PEDESTRIAN WIND ASSESSMENT, RESPONSE TO
SUBMISSIONS

CPP PROJECT 20269

164-194 William Street

Woolloomooloo, NSW

Figure 9: Public domain plan – Outdoor seating zones, with wind mitigation strategy outlined

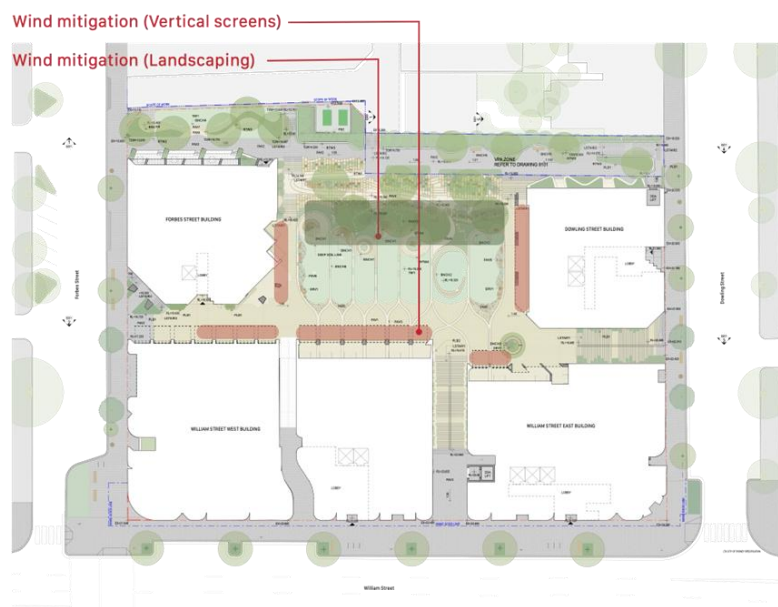
which is a reduction in comfort compared with the "Pedestrian sitting" rating of the earlier comparative scheme. The proposal must consider further mitigation measures to maintain comfort for sitting.	screens between seating areas, and tree planting to the north of the plaza (Figure 9) would be expected to improve the wind conditions in the Central Plaza space. These measures are considered appropriate for achieving the desired outcome. The combined wind conditions in the Central Plaza are shown to be suitable for pedestrian sitting in the concept DA and Uniform Uplift schemes (Configurations B and D, respectively). With the proposed mitigation measures, Pedestrian Sitting is expected to be achieved in the Central Plaza for the SSDA design (Configuration C).
Prepare an updated wind assessment that addresses the rooftop communal open space areas and private open spaces. Demonstrate the proposal will achieve acceptable safety and comfort levels of these areas. Provide further plans/details and mitigation measures, as needed, to demonstrate that the wind conditions in these areas will provide comfortable conditions for the intended use of the spaces.	Rooftop testing was conducted on a flat roof in Configuration D to determine baseline results for use in predicting the conditions in the final configuration. The proposed roof layout (Figure 10 and Figure 11) includes a perimeter balustrade or parapet, landscaped zones and semi-enclosed areas. In addition, roof articulation to the south and the plant/lift overrun would provide shielding from certain wind directions, increasing the proportion of time that the rooftop open spaces are suitable for resident use. For the rooftop private terraces, the proposed parapet height is 1.1 m. For the West building communal terrace, the combined perimeter screening height is 1.9 m (Figure 12). The expected wind comfort on the rooftop areas of the final design is anticipated to range from Pedestrian Sitting in the semi enclosed spaces and more sheltered southern areas, to Pedestrian Walking near the northern edges. These conditions are typical for rooftop environments and is considered appropriate for the proposed development. Calm areas, suitable for sitting, are expected to be available for most wind directions. The rooftop terrace areas of the final design are expected to satisfy the Lawson safety criteria.

The Central Plaza achieves a comfort rating of "Pedestrian standing"	The measured wind conditions in the park without landscaping are similar to those experienced in Belmont and Wynyard Parks. The proposed mitigation measures incorporating vertical

Testing was conducted without landscaping. Wind mitigation for seating areas within the Central Plaza region is proposed in the form of vertical screens between seating areas, and landscaped areas as outlined in Figure 9. Appropriately designed, these measures would have a significant benefit to the local wind conditions to create localised calm areas suitable for longer-term stationary activity meeting the Sitting classification.
